NUCLEAR REACTOR LABORATORY

January 29, 2004

Re: Response to Initial Request for Additional Information on the Relicensing of the
MIT Research Reactor, License No. N-37, Docket #50-20.

Figure 1

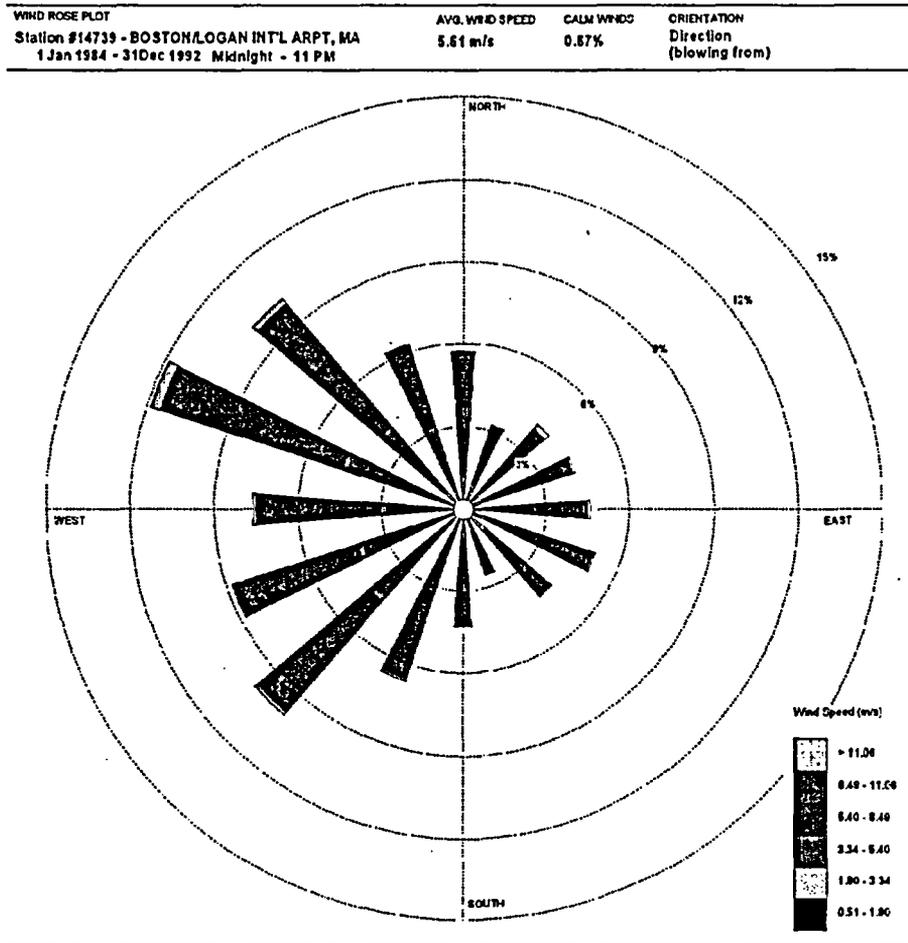
The wind profile information used for this input was the stability array (STAR) data obtained from the National Climatic Data Center (NCDC) for the Boston area and were included in the model by the author of CAP88PC at the request of the reactor facility. A wind rose plot of the NCDC data is provided within Figure 1 for Boston's Logan airport for the years 1984 through 1992.

Figure 2

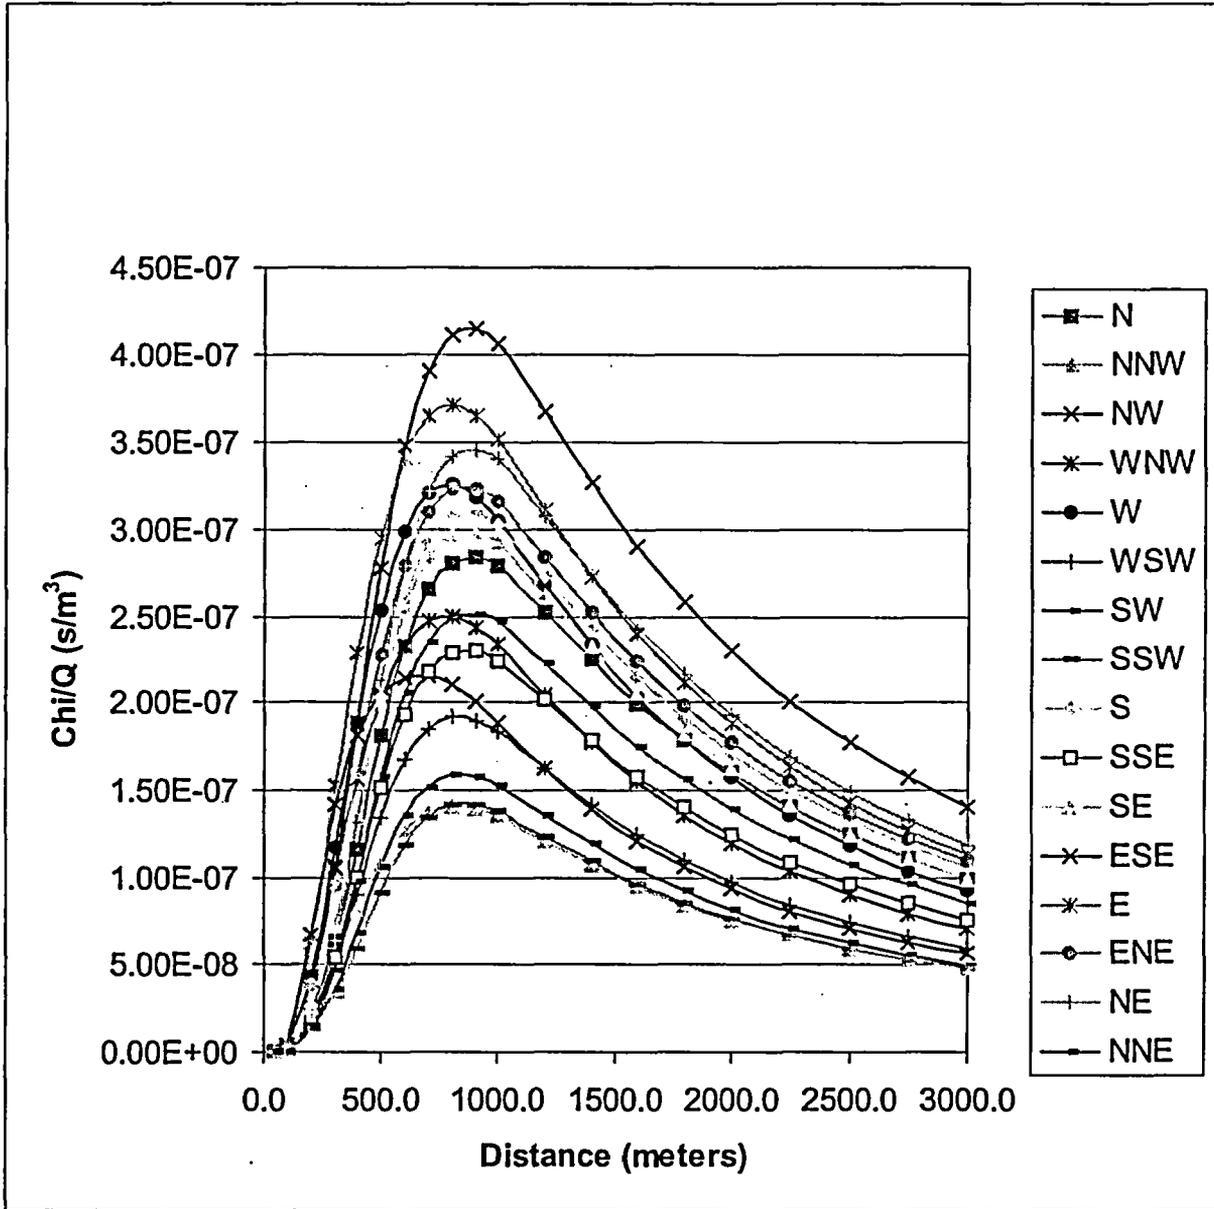
The maximal value of χ_{DW}/Q_s calculated for noble gases (^{41}Ar in this case) is about $4 \text{ E-}7$ at a distance of 900 meters ESE (represented as the wind direction toward ESE). The values of χ_{DW}/Q_s are shown in Table 1 along with a graphical depiction in Figure 2.

Figure 2. Coolant outlet temperatures of average and hot channels during a loss of primary flow transient. The initial conditions used for this analysis are reactor power at 7.4 MW, primary flow 1800 gpm, coolant outlet temperature 60 °C, and coolant height at 10 ft.

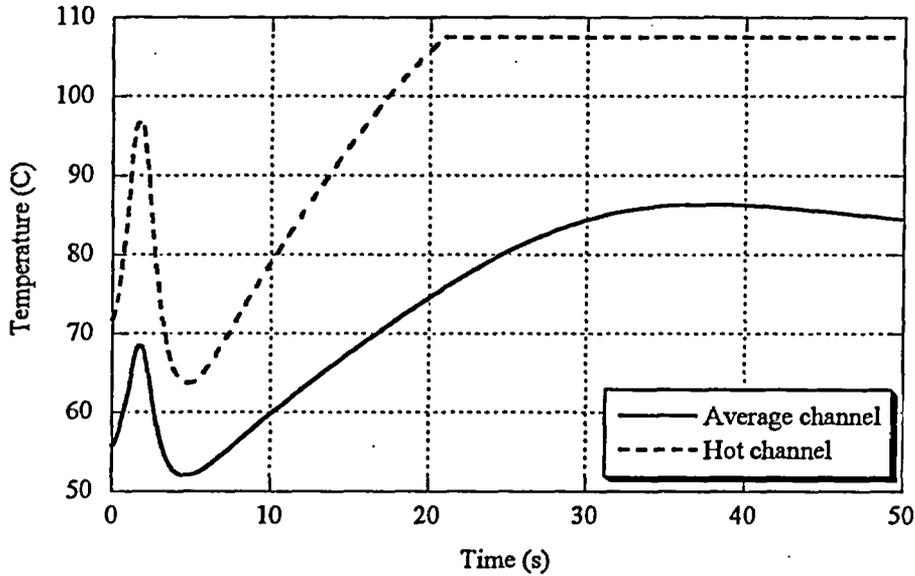
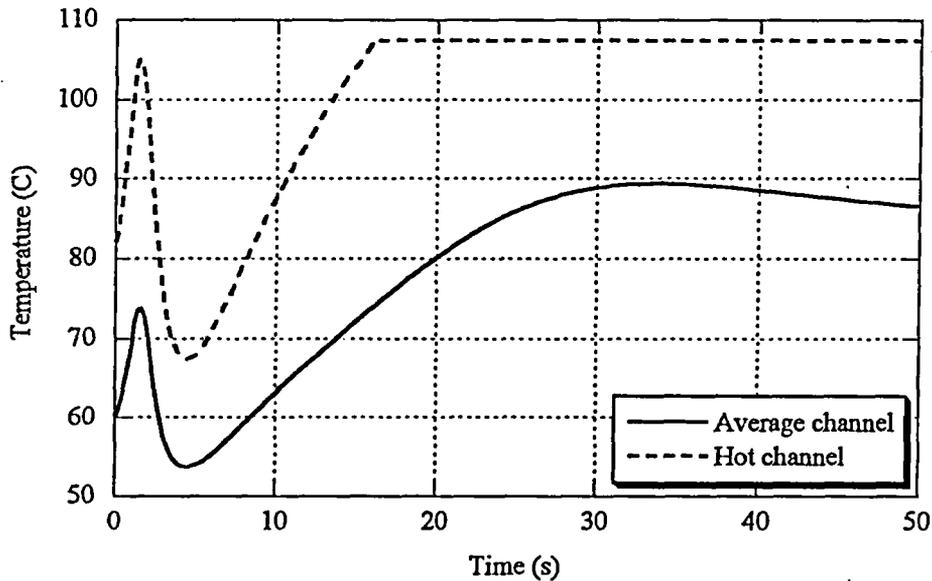
2. Figures 1 and 2 are comparisons of the coolant outlet temperatures of the average and hot channels for the two cases. Note that the initial coolant temperatures are higher in Figure 2 because of the higher initial power (7.4 MW v.s. 6.1 MW) and lower initial flow rate (1800 gpm v.s. 2000 gpm). The peak hot channel outlet coolant temperatures, which occur around 1.5 s into the transient, are 105.2 °C for case#2 and 97.0 °C for case#1. Note that the coolant temperature then decreases rapidly in both cases because of reactor scram. Both analyses showed that the hot channel coolant outlet temperature would reach saturation after about 15 to 20 seconds. Figure 3 shows the calculated fuel temperatures at the average and hot channel outlet assuming the initial conditions of the LOF transient are LSSS. The calculated fuel temperatures are well below the cladding softening point of 450 °C.

Figure 4 Reactor decay power calculated using DKPOWR assuming equilibrium power of 7.4 MW before reactor scram.

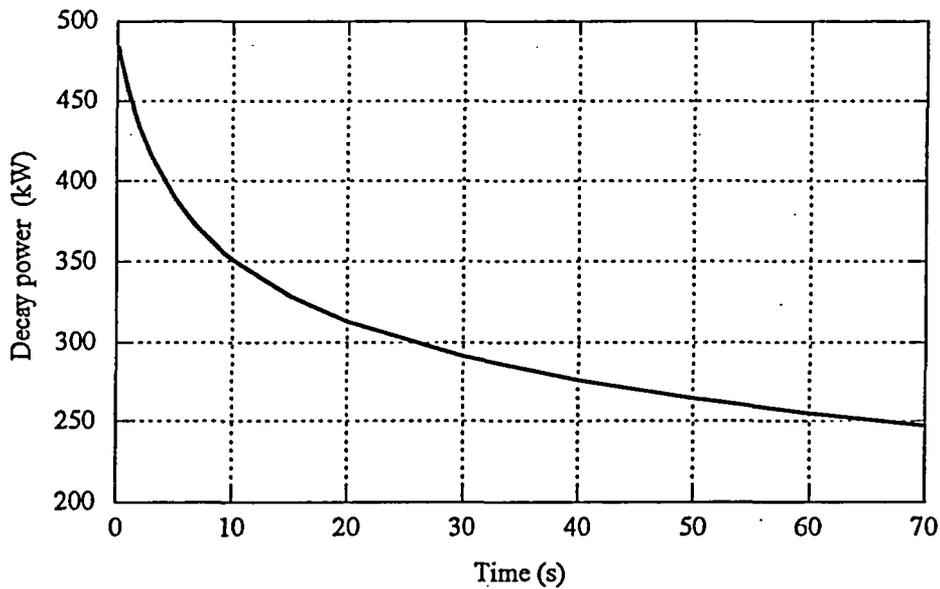
3. Figure 4 is the calculated reactor decay power assuming equilibrium reactor power was at 7.4 MW before scram. The reactor decay heat at 16 seconds after reactor scram is about 325 kW. As shown in SAR section 4.6.6.3, the best-estimate dry-out condition is 468 kW.
